ADDENDUM NO. 6

FOR THE CONSTRUCTION OF

JEFFERSON ELEMENTARY SCHOOL RENOVATION
JEFFERSON CITY, TENNESSEE

November 13, 2026

Site Layout

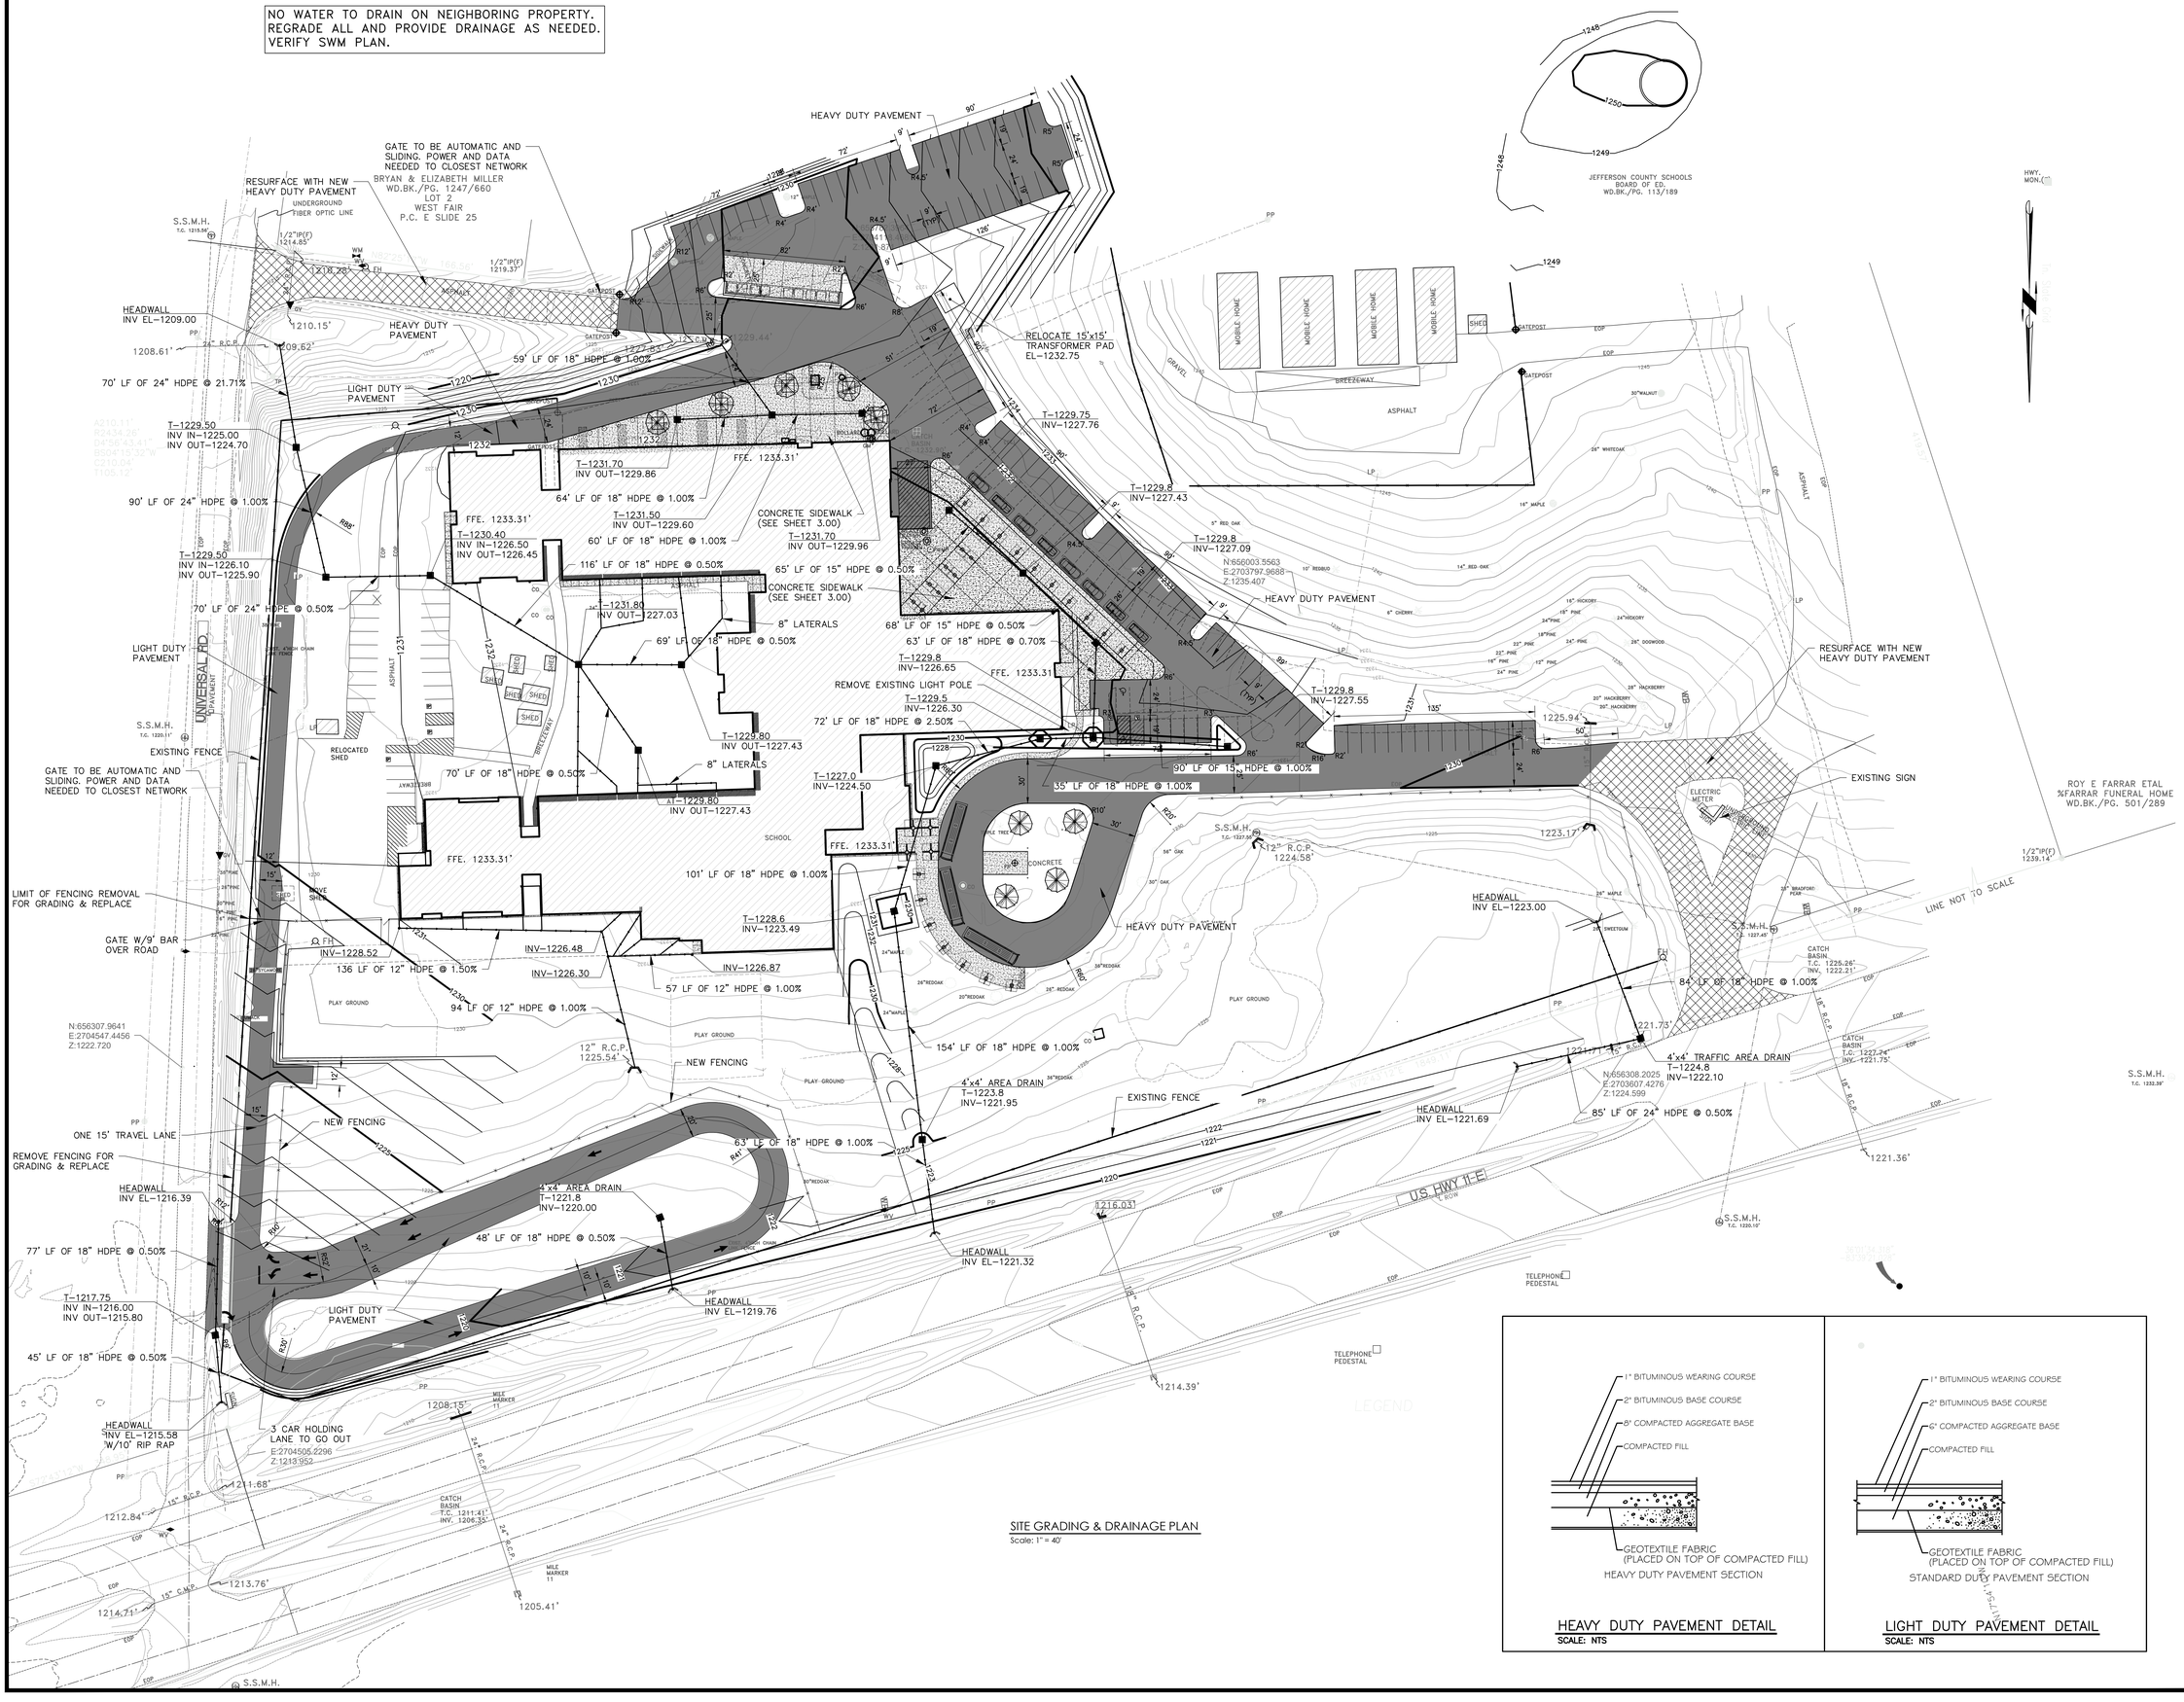
ITEM 1 **DELETE** Sheet **"**C1.00 - Site Layout (issue date: 9/01/26)" in its entirety.
ADD Sheet **"**C1.00 - Site Layout (issue date: 11/03/26)"

1. Added plan notes to reflect addendum notes.

Response: See the revises C1.00 and C2.00 sheets included in this Addendum.

Drawing Title:
Site Grading & Drainage Plan

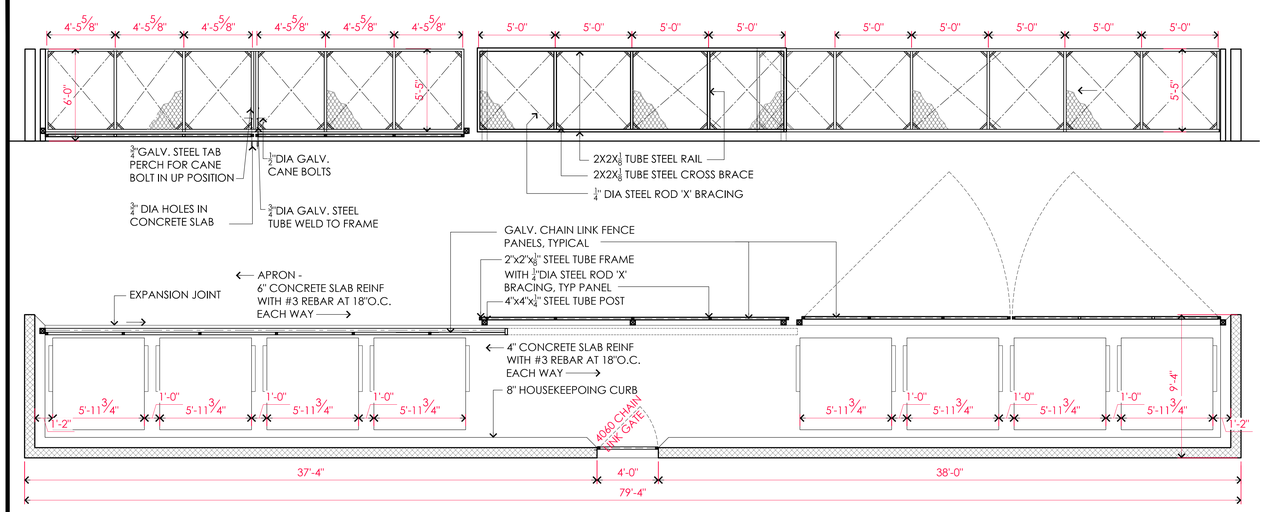
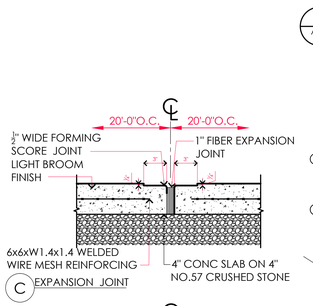
ITEM 2 **DELETE** Sheet **"**C2.00 - Site Grading & Drainage Plan (issue date: 9/01/26)" in its entirety.
ADD Sheet **"**C2.00 - Site Grading & Drainage Plan (revision 1 date: 11/03/26)".

1. Added plan notes to reflect addendum notes.

18. There is a "proposed water main" on C2.03 that tie into the bottom left portion of the building. The utility connection point on the plumbing drawings is shown in the top right part of the building (above the kitchen). There is no utility line shown in that part of the site. Please advise. There are also new sanitary sewer utility connections shown on P5.1 that are not shown on the utility plans.

Drawing No.:
A0.2 ⚠

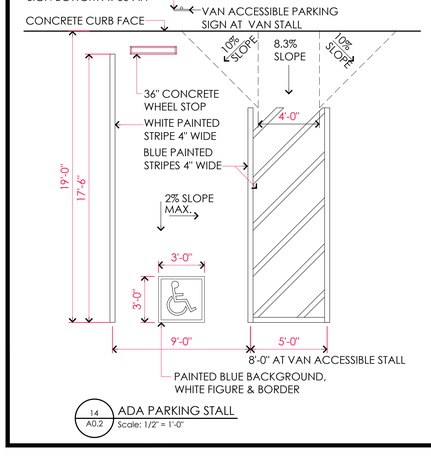
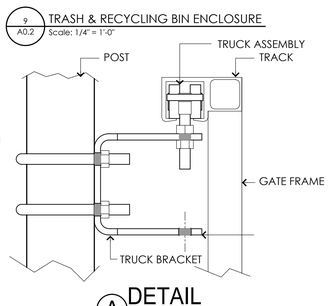
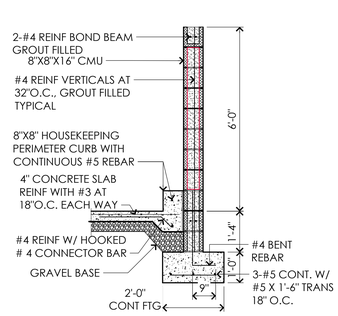
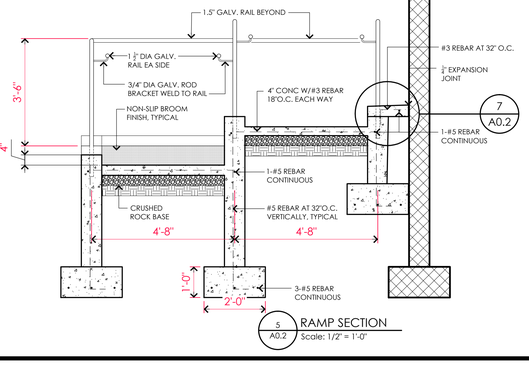
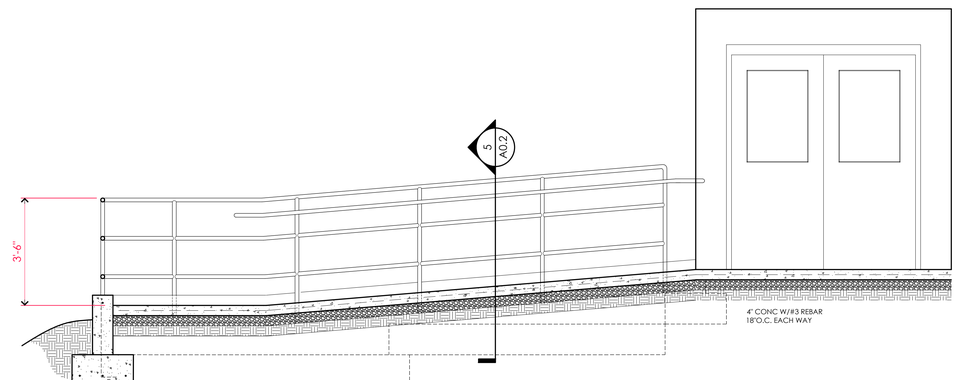
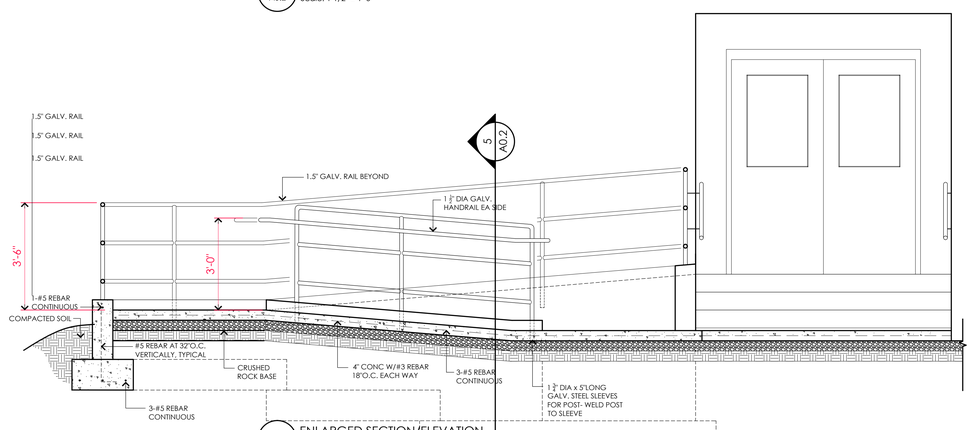
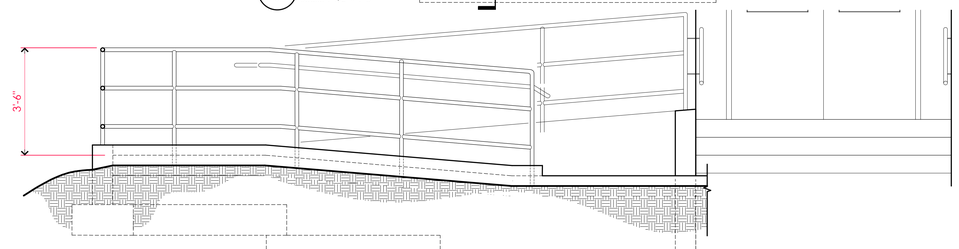
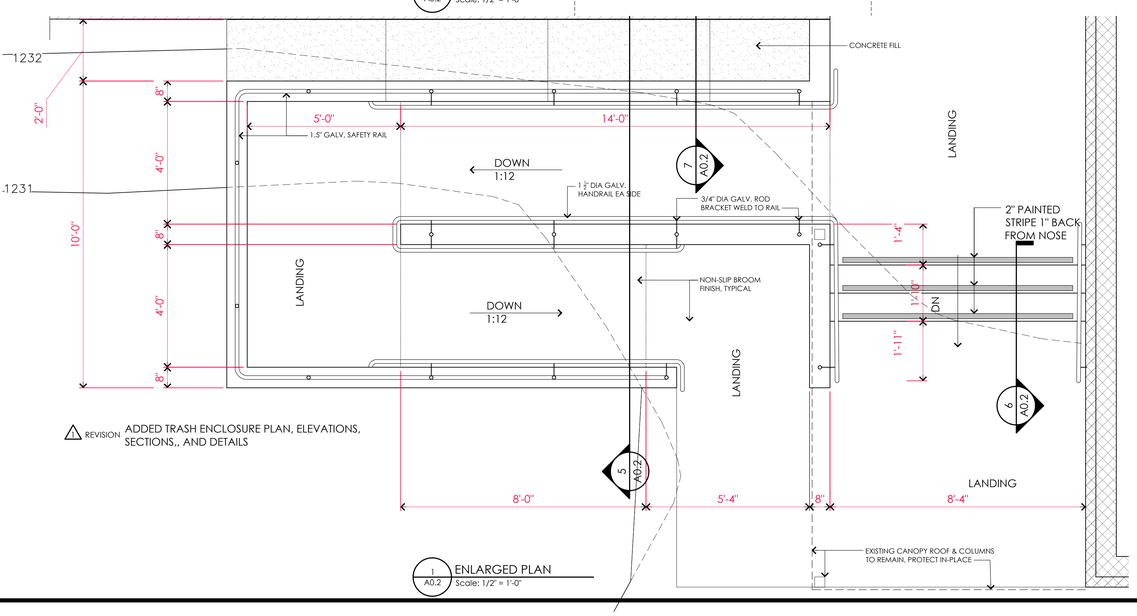
ITEM 3 **ADD** Sheet **"**A0.2 - Site Details (revision 1 date: 11/03/26)".

11. Sheet A0.2 SITE DETAILS is listed in the drawing index and referenced on A0.1, but it is not included in the bid set. Please issue A0.2. Does it include chain link fence, gate, post footing, or building termination details?

⚠ REVISION ADDED TRASH ENCLOSURE PLAN, ELEVATIONS, SECTIONS,, AND DETAILS

Response: Sheet A0.2 – Site Details has been included in this addendum.

Enlarged Restroom Plans

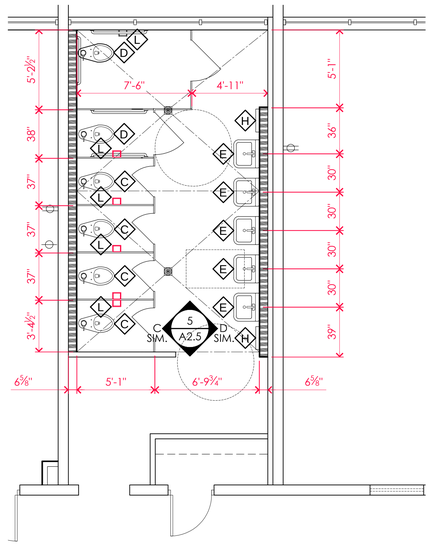
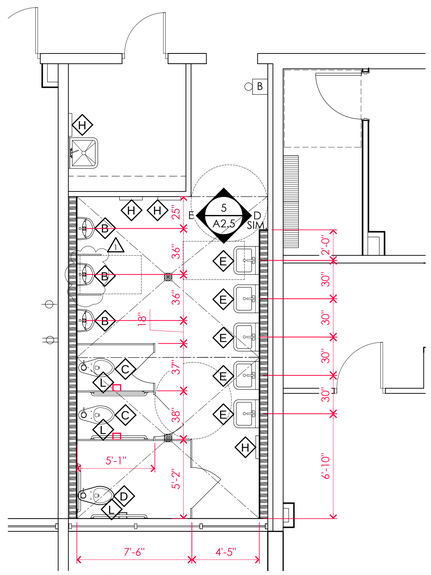
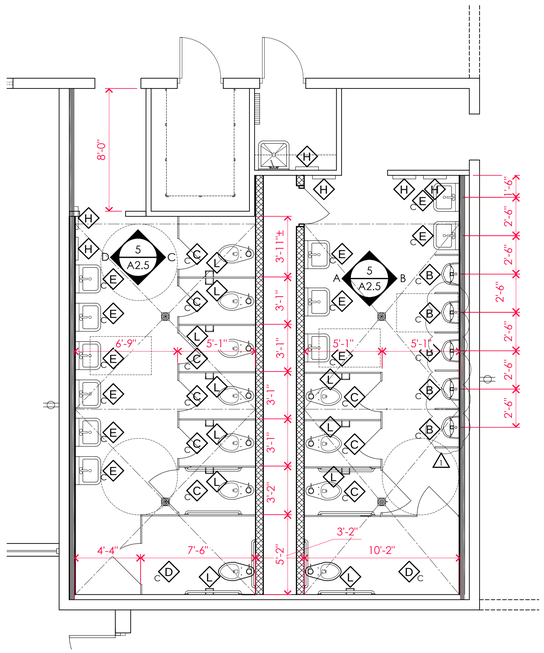
ITEM 5 **DELETE** Sheet **"**A2.5 - Enlarged Restroom Plans (issue date: 9/01/26)" in its entirety.
ADD Sheet **"**A2.5 - Enlarged Restroom Plans (revision 1 date: 11/03/26)".

1. Indicated urinal screens in boys restroom to reflect addendum notes.

9. On page A2.5 I see the elevations have urinal screens but the enlarged plans don’t. Are there urial screens and if so, what are the dimensions needed and how many for each restroom. Maybe I missed an addendum page that had these labeled?

Response: The urinal screens will be required. See revised A2.5 and A2.7 sheet for quantities and dimensions.

Drawing Title:
Enlarged Restroom Plans

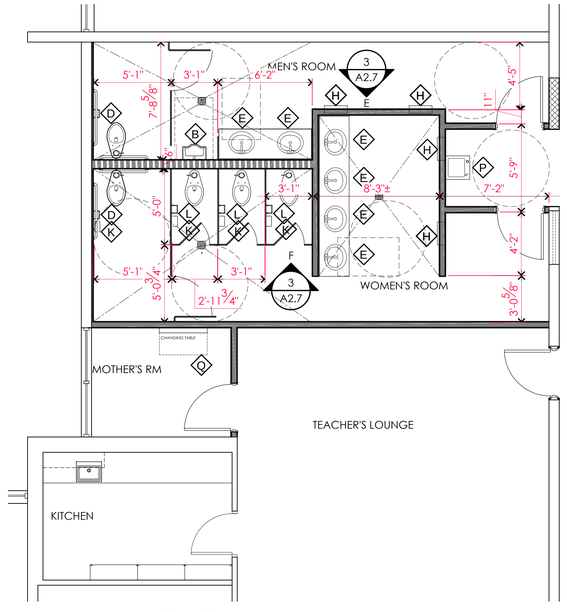
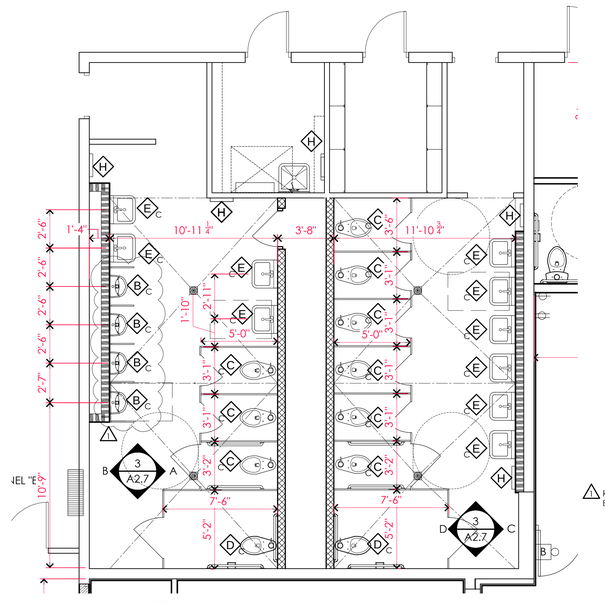
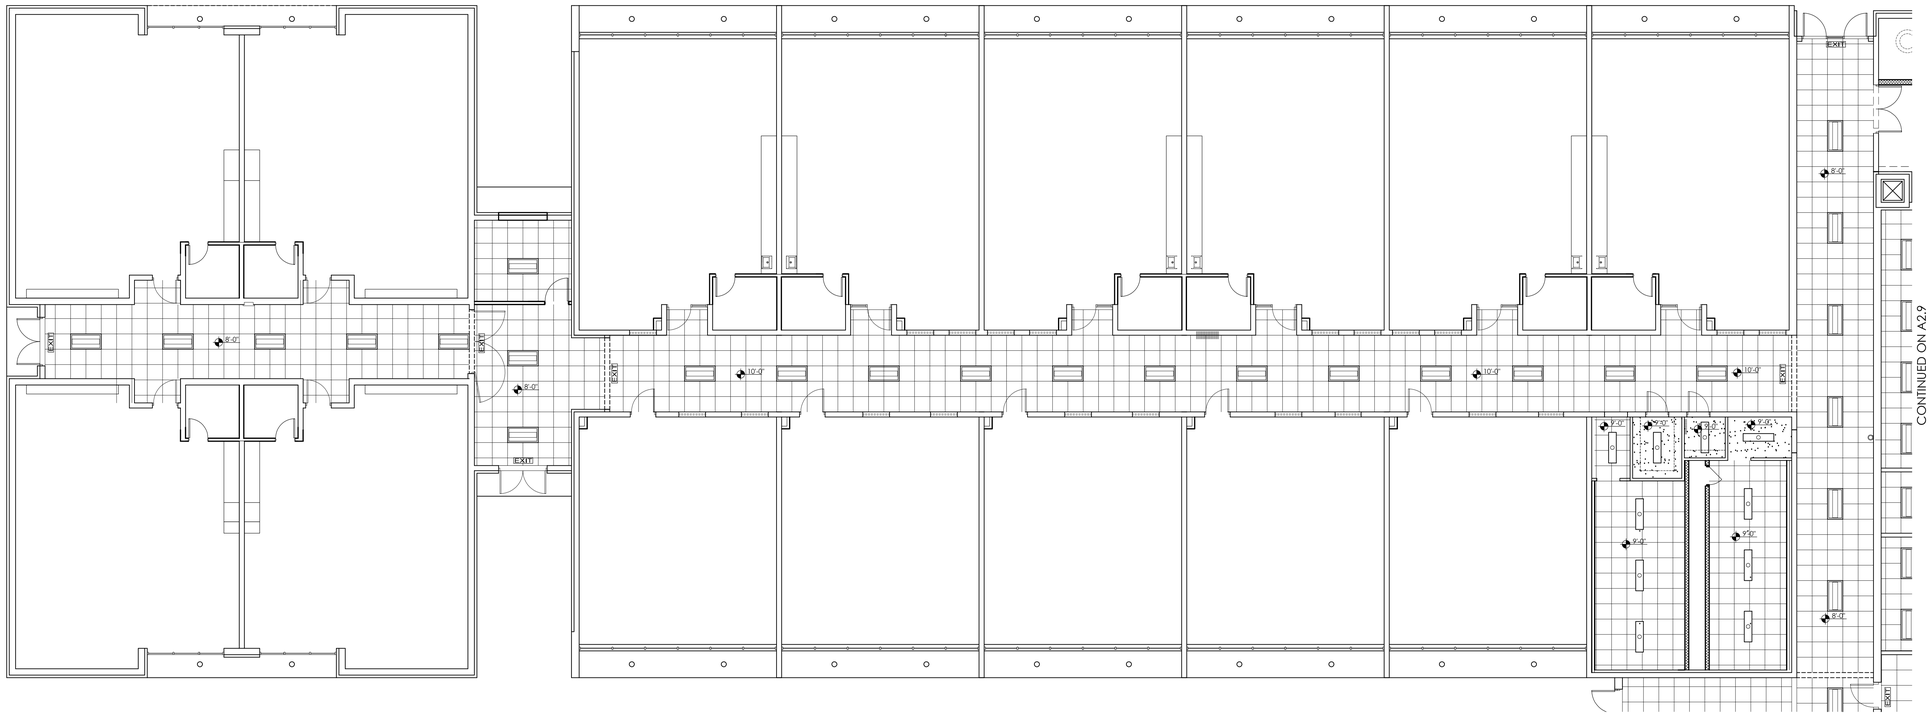
ITEM 6 **DELETE** Sheet **"**A2.7 - Enlarged Restroom Plans (issue date: 9/01/26)" in its entirety.
ADD Sheet **"**A2.7 - Enlarged Restroom Plans (revision 1 date: 11/03/26)".

1. Indicated urinal screens in boys restroom to reflect addendum notes

Drawing Title:
Blue Hall Reflected Ceiling Plan

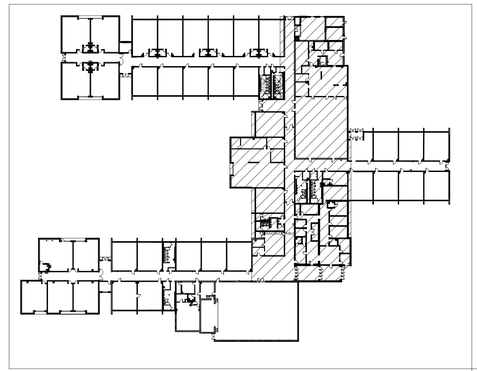
ITEM 8 **DELETE** Sheet **"**A3.1 - Blue Hall Reflected Ceiling Plan (issue date: 9/01/26)" in its entirety.
ADD Sheet **"**A3.1 - Blue Hall Reflected Ceiling Plan (revision 1 date: 11/03/26)".

1. Boys & Girls ceilings change to acoustical tile ceiling panels and grid.
